HISTORIC AND DESIGN REVIEW COMMISSION

Agenda Item No: 20

HDRC CASE NO: 2015-196
ADDRESS: 500 KENDALL ST
LEGAL DESCRIPTION: NCB 1735 BLK 14 LOT 18
ZONING: R6 H
CITY COUNCIL DIST.: 1
DISTRICT: Tobin Hill Historic District
APPLICANT: Mario Herrera
OWNER: Americo Canales
TYPE OF WORK: Exterior alterations
REQUEST:

EXISTING FIRST FLOOR PLAN
SCALE: 1/4" = 1'-0"

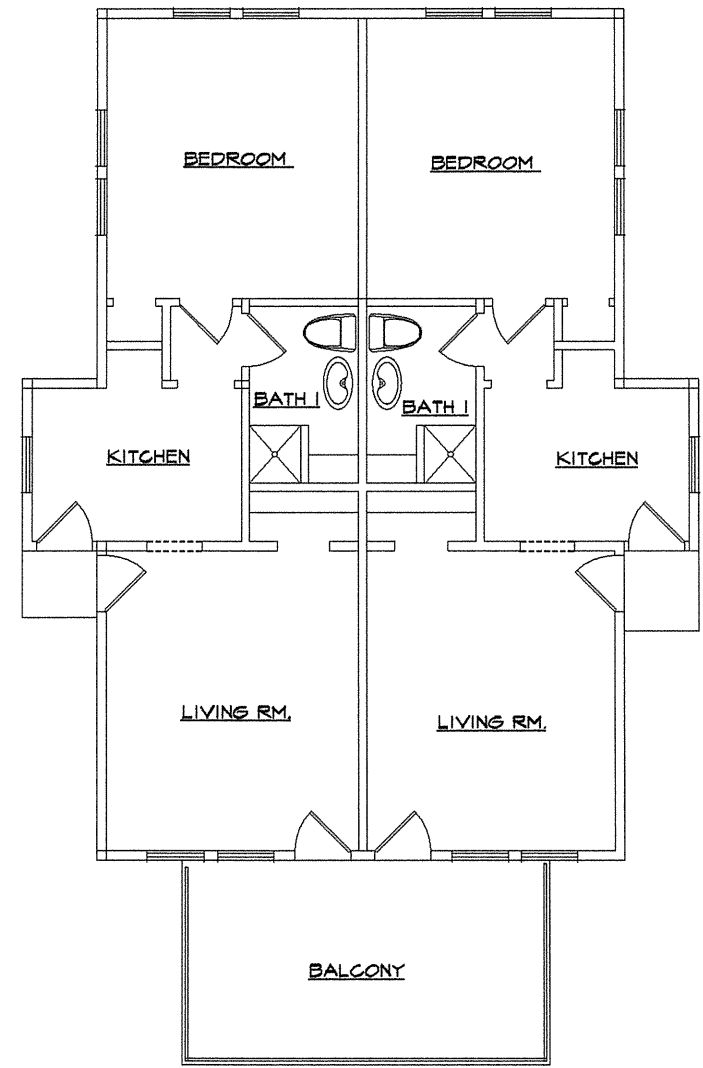
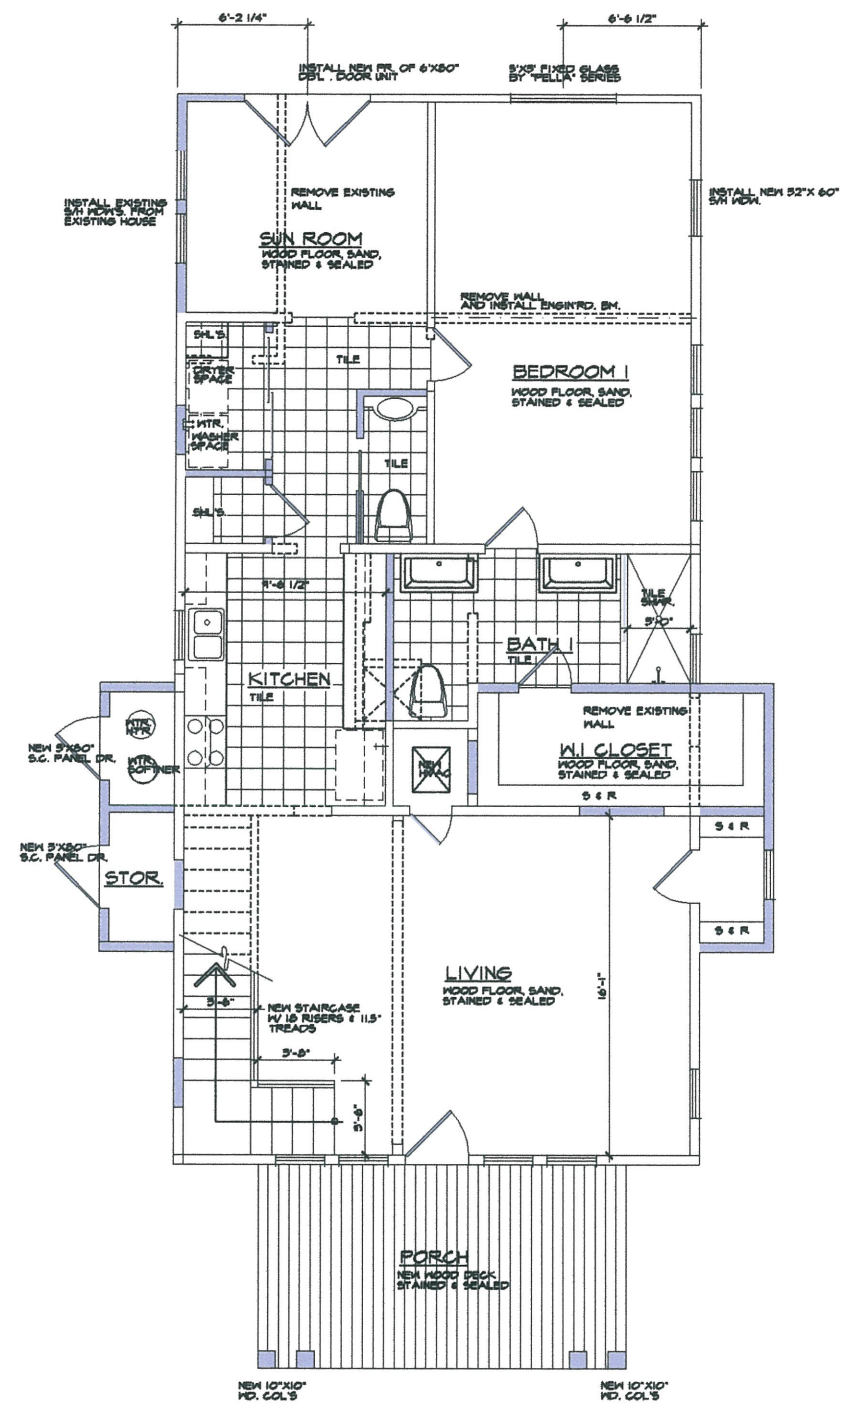
- e. According to the Guidelines for Exterior Maintenance and Alterations, side porches and original architectural details should not be obscured by enclosure materials. The existing wall offset on the south side appears to be original to the house and should be preserved. The existing wall offset on the north side is likely a later addition and modifications to this element will not impact the historic portions of the house.

- h. According to the Guidelines for Exterior Maintenance and Alterations, existing windows and window openings should be preserved. The proposed windows to be infilled are located in the main portion of the house and are likely original to the structure. Filling in these windows is not consistent with the guidelines and should be avoided.

- 1-3. Staff recommends approval as submitted based on findings b-d.
- 4. Staff does not recommend approval as submitted based on findings a and e. Staff recommends the original portion of the house is preserved.
- 5. Staff recommends approval based on findings f and g with the following stipulations:
 - a. The siding is smooth and painted
 - b. The new additions are differentiated from the old
- 6. Staff does not recommend approval based on finding h. If the existing window pattern does not fit with the new interior layout staff recommends the windows are covered on the inside only so that the windows remain on the exterior.

REVISED FIRST FLOOR PLAN
SCALE: 1/4" = 1'-0"

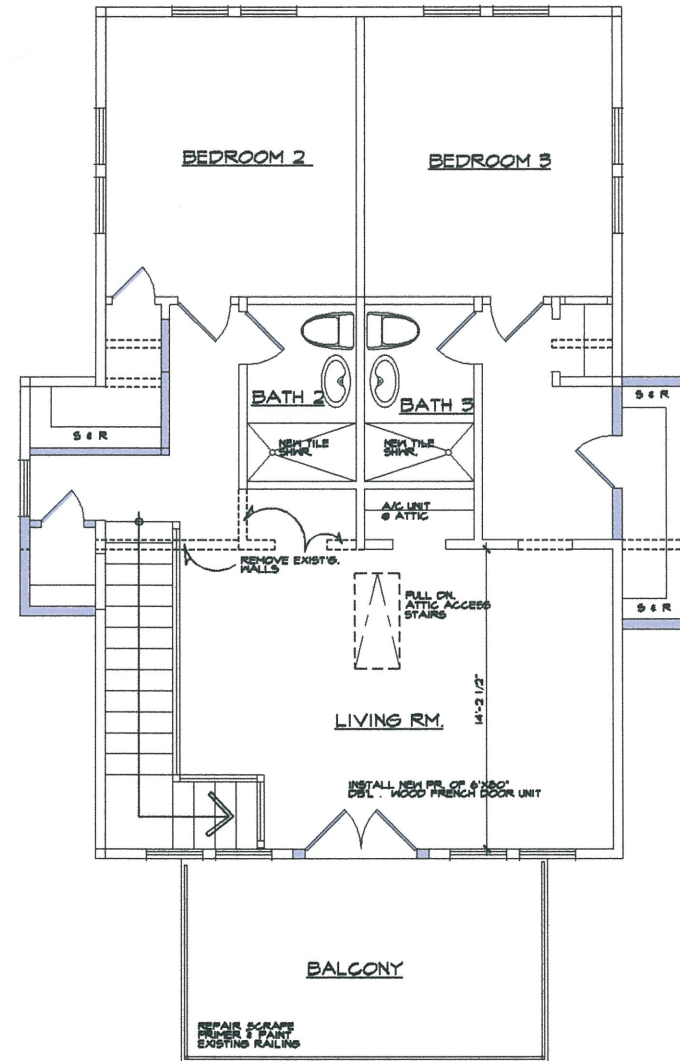
- f. As recommended by the Guidelines for Additions, new additions should be located at the side or rear of the building, use a similar roof form and a setback or recessed area to provide clear distinction between old and new. The proposed addition is in keeping with the guidelines in location and roof form, however the walls of the addition will align with the walls of the main house and will not provide a clear separation between old and new.

FRONT ELEVATION
SCALE: 1/4" = 1'-0"

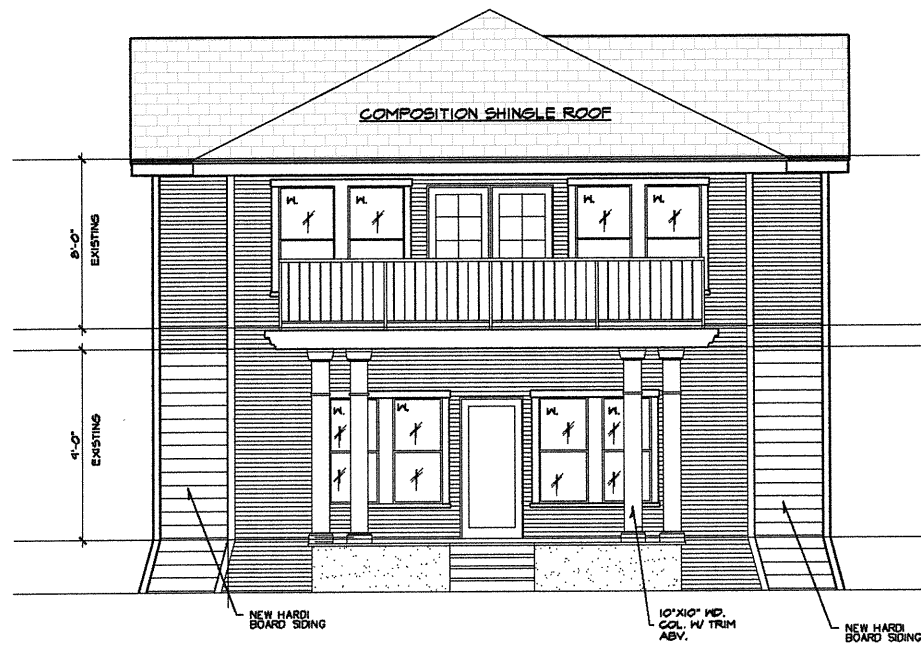
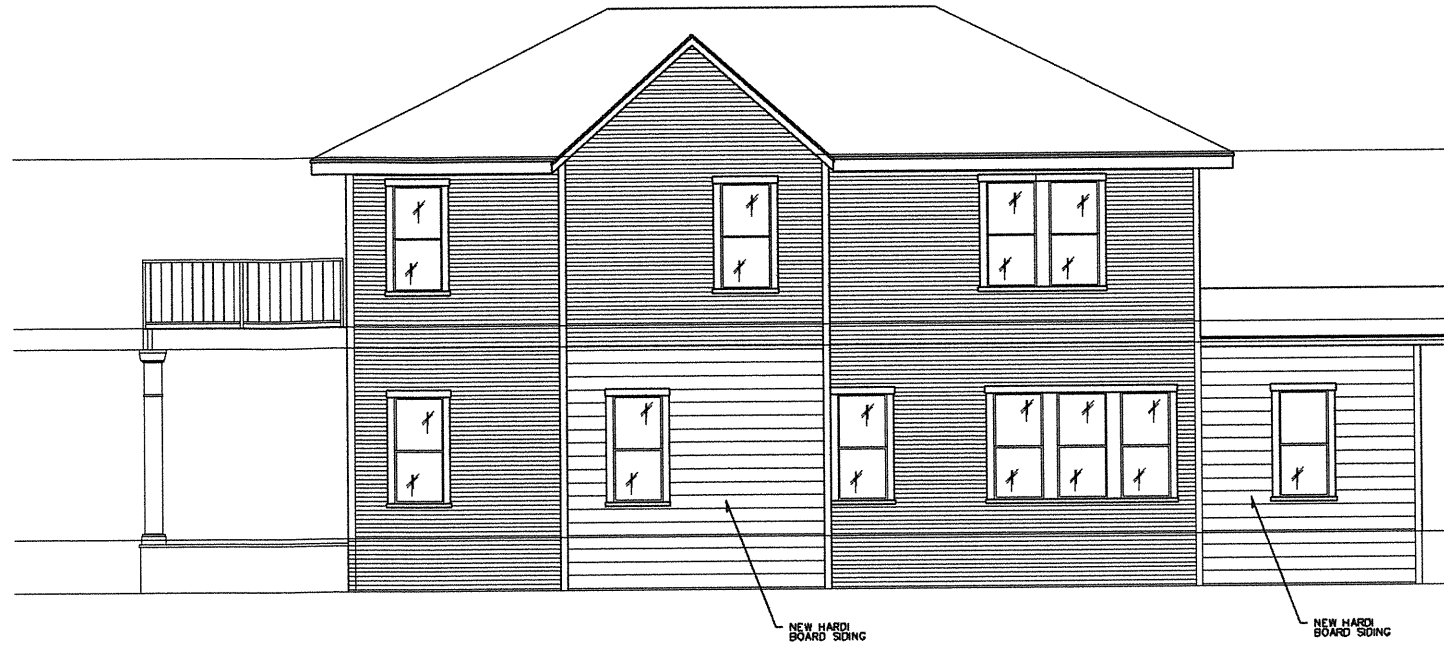
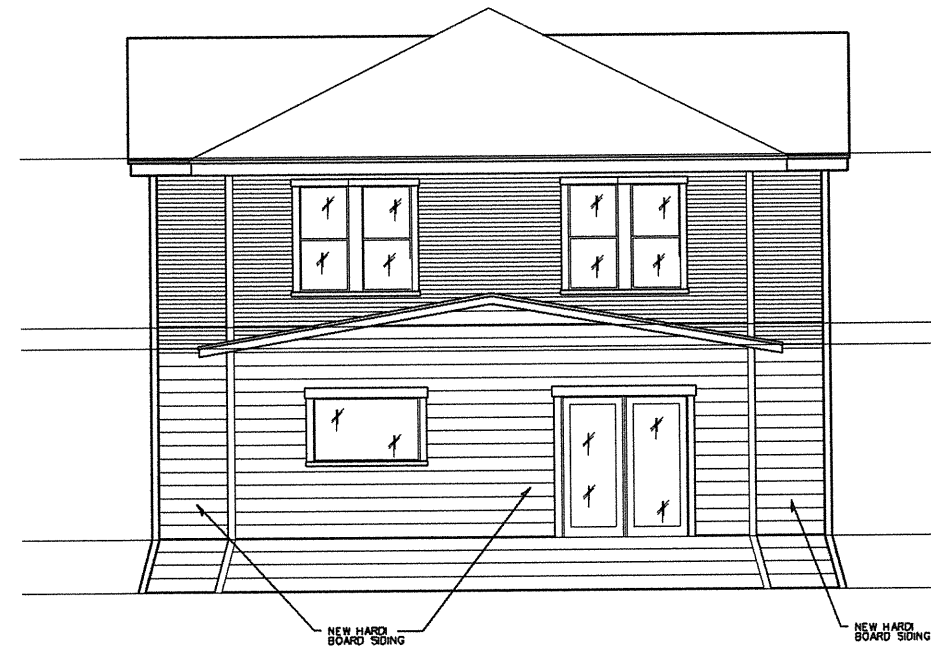
- d. Consistent with the Guidelines for Exterior Maintenance and Alterations, porch elements should be replaced in kind or with new elements that are compatible to the style of the structure. The proposed replacement columns are consistent with the guidelines.

- g. Consistent with the Guidelines for Additions, materials that match in type, color and texture should be used. The proposed hardi board siding may be appropriate for this installation.
